# Access Compliance Report

## Public Rights-of-Way

### (Curb Ramps)

Intersection ID: N/A	Main Street: NATIONS_FORD_RD	Cross Street: IVERIFY	Location: SE
ADA ID: A0CB6A34D54E	Ramp Type: ParaDiag	Initial Pass/Fail: Fail	Overall Compliance: No
		Severity Score: 25

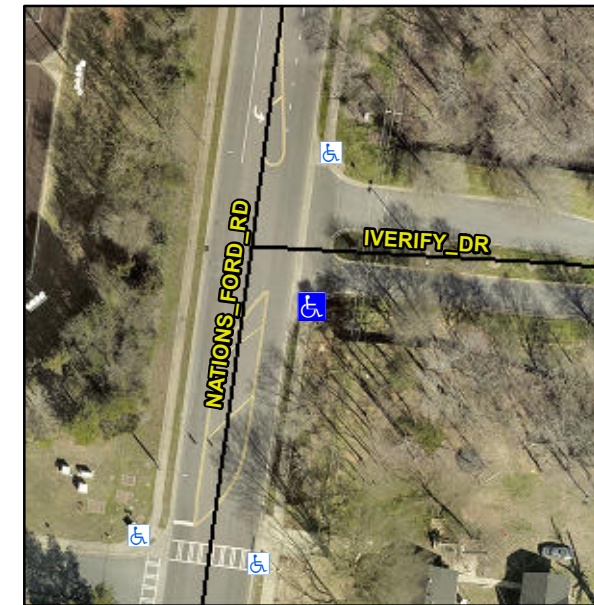
Surveyor Notes:

**LT RP < 5%**

PROW/ADA:

**R304.3.2**

Possible Solutions:

**Remove & Replace Curb Ramp With Two New Directional Ramps or Equivalent.**
